UNITED STATES PATENT AND TRADEMARK OFFICE

APPLICATION NO.	FILING DATE	FIRST NAMED INVENTOR	ATTORNEY DOCKET NO.	CONFIRMATION NO.
10/840,145	05/06/2004	Jack C. LaSee	110327.00003	7416
23598 7590 05/14/2008 BOYLE FREDRICKSON S.C. 840 North Plankinton Avenue MILWAUKEE, WI 53203				
EXAMINER				
GILBERT, WILLIAM V				
ART UNIT		PAPER NUMBER		
3635				
NOTIFICATION DATE		DELIVERY MODE		
05/14/2008		ELECTRONIC

Office Action Summary

DETAILED ACTION

Figure 5 from Stark

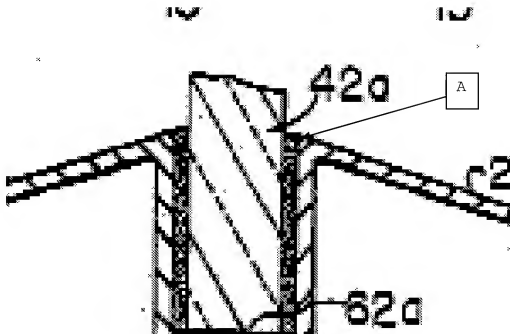
Claim 1: Stark discloses a window panel comprising first and second flange units (Fig. 5: 22a, 20a, respectively) each comprising a preassembled rectangular frame (Fig. 1, generally), sash elements (32a, 28a, respectively) that extend into the opening to capture a transparent pane (42a), at least one retention member (52a) attached to the first flange unit and extending into the opening to grip a sill surface (64a) to retain the first flange unit (22a) and the sash element in position for assembly, and at least one fastener (15a) adapted to draw the first and second flanges and the sash elements together against the pane, the sash elements include inwardly spring biased sharp edge portions (see "A" from attached Fig. 5 from Stark, below, and the edge portions are spring-biased via

fastener, 15), and the elements are spring biased via fastener (15a) in contact with the pane and the edge portion would embed in the pane when the pane is in a semi-molten state. The language "wherein said sharp edge...semi-molten in fire" lines 13 and 14 are steps that relate to a desired result and the examiner contends that as a glass pane becomes molten, it will inherently soften which would result in virtually anything imbedding in the pane if a force (such as a spring bias against the sharp edge) were applied to it. Regarding the limitation "preassembled", the limitations are drawn to method steps and only the final product, the apparatus, is provided patentable weight.

Figure 2 from LaSee

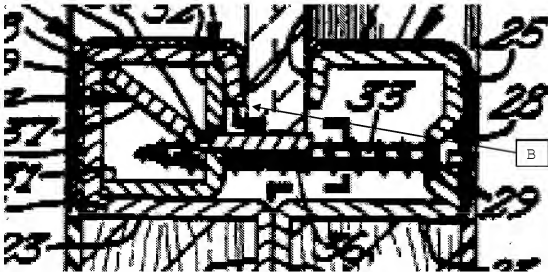
Claim 1: LaSee discloses a vision panel (Fig. 1: generally) having a first and second flange units (25), each comprising a preassembled rectangular frame (see Fig. 1, generally where the frame, portion 18, is a rectangular frame) that abut a front and rear face of the door (10), sash elements (26) that extend into the opening and capture a transparent pane (19) within the opening, a retention member (31) attached to the first flange and extending into the opening to grip a sill surface of the opening to retain the first flange unit and sash elements in position, and a fastener (33) that draws the first and second flanges and sash elements together against the pane, and the sash elements (26) have inwardly spring biasing sharp edges (see "B" from attached Fig. 2 from LaSee, below,) and the elements are spring biased via fastener (28) in contact with the pane and the edge portion would embed in the pane when the pane is in a semi-molten state. The language "wherein said sharp edge...semi-molten in fire" lines 13 and 14 are steps that relate to a desired result and the examiner contends that as a glass pane becomes molten, it will inherently soften which would result in

virtually anything imbedding in the pane if a force (such as a spring bias against the sharp edge) were applied to it.

Claim 19: the sash elements include inwardly biased sharp edges (see "B" above) that would embed in the panel member when the panel becomes semi-molten.

The examiner respectfully disagrees with applicant's interpretation of the "sharp edge portions", and "spring-biased". With regards to the "sharp edge portions", the examiner contends that the portions indicated in the rejection above (with an added figure from LaSee) are sharp edged as each terminates in a point. To claim the limitation that these will embed in the pane when the pane becomes semi-molten in fire relate to method steps and intended use of the member. If the glass in the prior art of record cited above were to become molten, the examiner contends that the sashes would imbed in the glass. Further, the examiner contends that the members are "spring biased" due to the threaded member that holds the two sashes together. The resulting force drawing the two sashes together would result in a spring force.
